Access Compliance Report Public Rights-of-Way (Curb Ramps)

Main Street: CASTLEGATE_LN Cross Street: MARQUIS_CIR Location: NE

ADA ID: RPRK211011110603 Ramp Type: Type 1 - Perpendicular Diagonal Initial Pass/Fail: Pass Overall Compliance: No Severity Score: 15

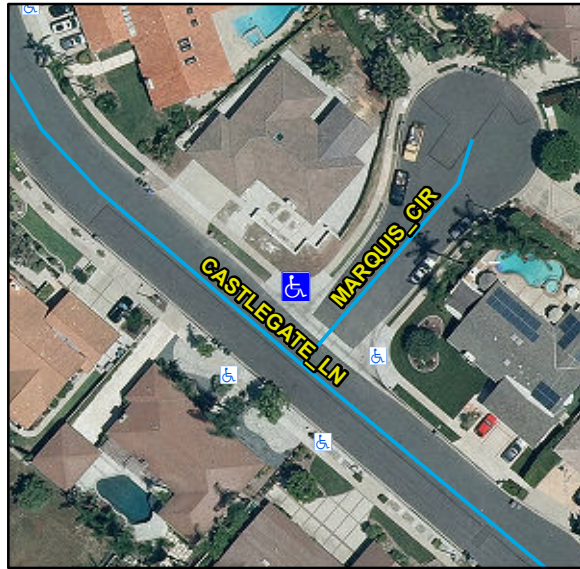
Compliance	Description	Data	Compliance	Description	Data
N/A	Ramp Length (in)	86	N/A	Flare Type LT	
Yes	Ramp Width (in)	48			Sloped
Yes	Ramp Run Slope (%)	6.6	Yes	Flare Slope LT (%)	8
Yes	Ramp Cross Slope (%)	0.5	N/A	Flare Traversable LT	Yes
N/A	Landing Present	No	N/A	Flare Type RT	
N/A	Landing Length (in)	N/A			Sloped
No	Landing Width (in)	N/A	Yes	Flare Slope RT (%)	9.9
No	Landing Run Slope (%)	N/A	N/A	Flare Traversable RT	Yes
No	Landing Cross Slope (%)	N/A	Yes	DWS Provided	Yes
N/A	Landing Movement Obstructed?	Yes	Yes	DWS Contrast	Yes
	Landing Movement Type	Curb	Yes	DWS Length (in)	36
N/A	Landing Shared	N/A	Yes	DWS Full Width	Yes
N/A	Clear Space	Yes	Yes	DWS Offset Left (in)	0
N/A	Clear Space To Crosswalk (in)	48	Yes	DWS Offset Right (in)	N/A
N/A	Marked Crosswalk 1	No	N/A	Marked Crosswalk 2	No
	Crossing 1 Direction	SW		Crossing 2 Direction	SE
	Marked Crosswalk 1 Width (in)	N/A		Marked Crosswalk 2 Width (in)	N/A

N/A	Ramp Inside Crosswalk 1	N/A	Yes	Ramp Inside Crosswalk 2	N/A
	Crossing 1 Slope (%)	8.5		Crossing 2 Slope (%)	3.8
	Crossing 1 Cross Slope (%)	2		Crossing 2 Cross Slope (%)	2
Yes	Gutter Ponding	No	No	Curb Slope	13.8
Yes	Gutter Lip Height (in)	0		Road Run Slope (%)	2.6
No	Gutter Run Slope (%)	5.3		Road Cross Slope (%)	8.1
Yes	Gutter Cross Slope (%)	1.8			
Yes	Overall Surface Condition: Acceptable		Yes	Perp Joint Present	Yes
	Cross Gutter Present?	Yes		Spandrel Present?	Yes
	Replace Cross Gutter?	No		Replace Spandrel?	No

Remove & Replace Curb Ramp With Two New Directional Ramps or Equivalent. Remove & Replace Gutter.
